DST Consulting Engineers Inc.

Site
2555 Sheffield Road, Ottawa, ON

Report Title
Sheffield Recycling Facility

Drawing Title: **Cross-Section Views**

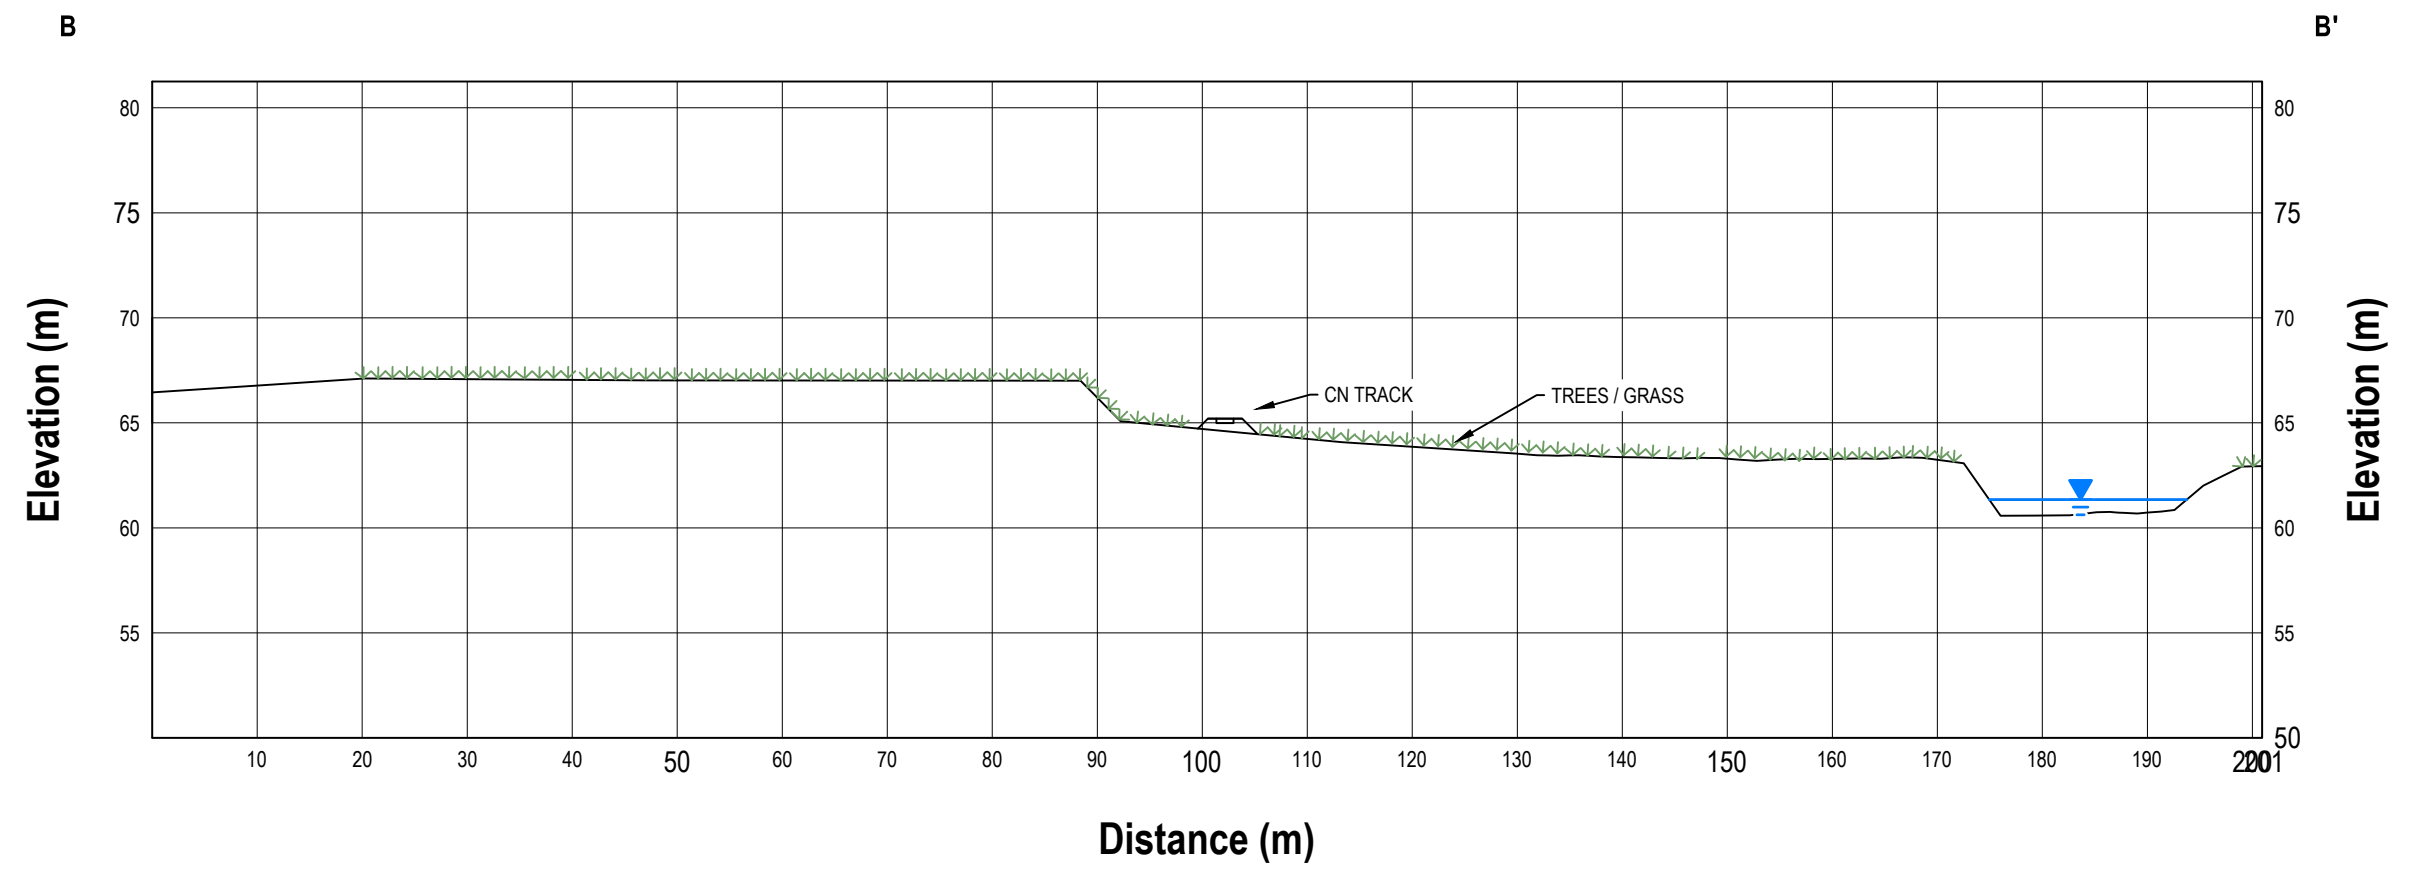
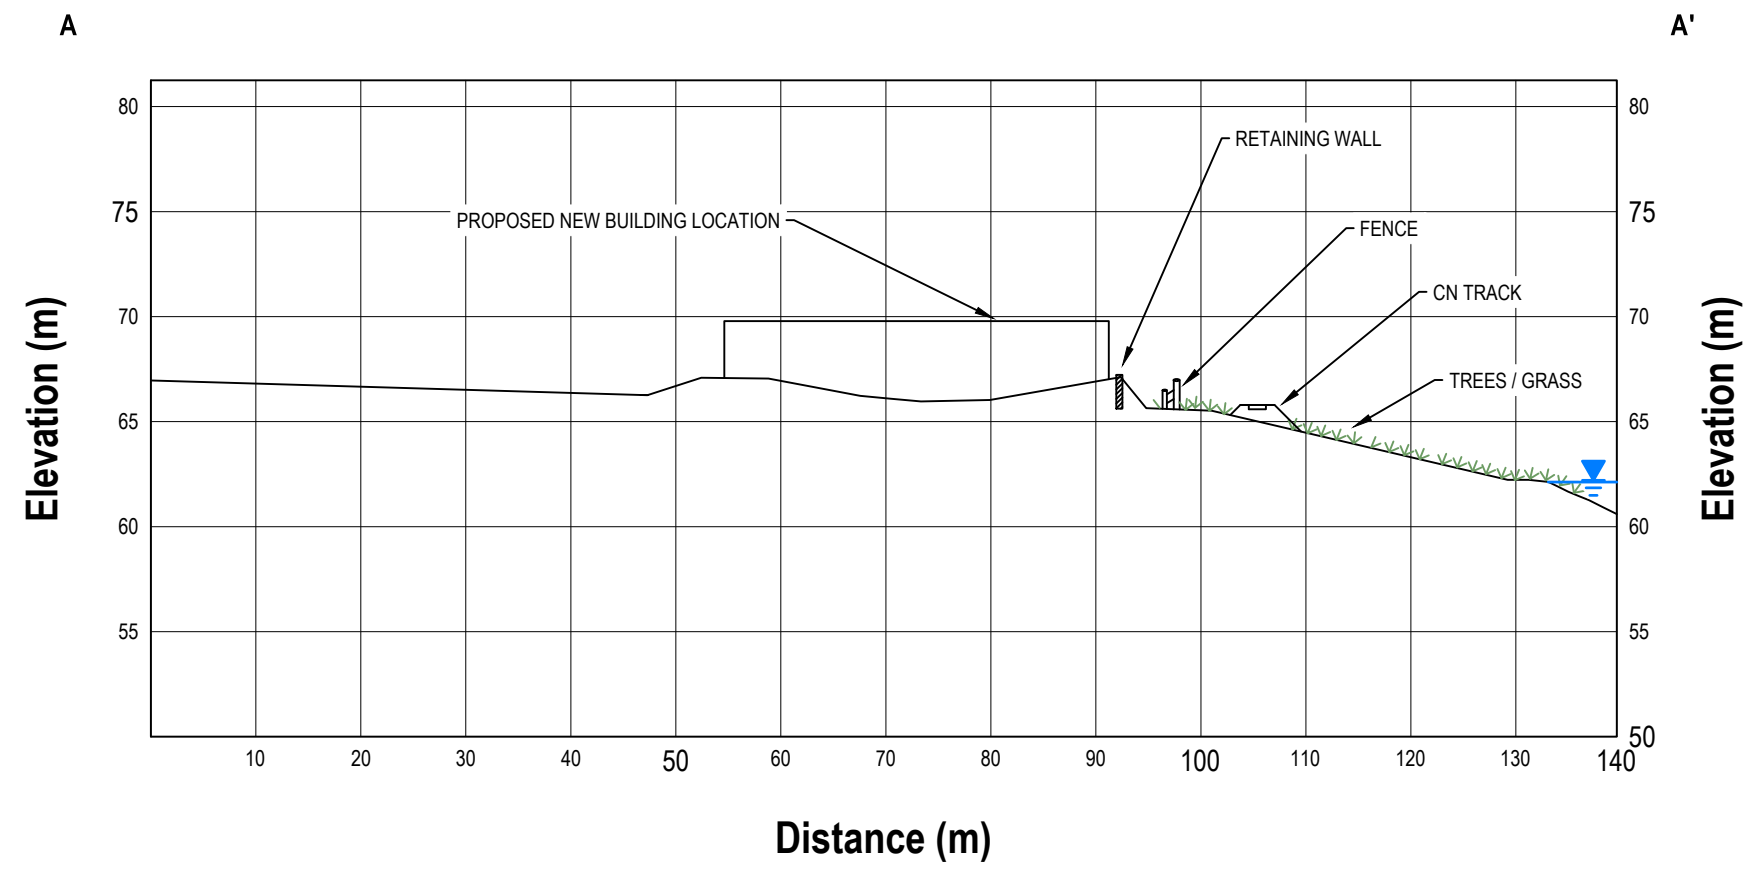
DST visited AIM recycling facility on October 16, 2019, to inspect slope between the AIM property and Ramsay Creek. Following that, DST conducted a topographic survey to establish ground elevations at the boundaries of the mentioned property, to come up with two cross-sections (Refer to Figure 2, Appendix A for cross-section locations) , which demonstrate the shape of the slope and land between the mentioned property and Ramsay Creek.

Based on the topographic survey that was completed by DST, along with slope inspection, DST recommends that this reach of the Ramsay Creek be considered as an unconfined river and stream system (Refer to site photos in Appendix C).
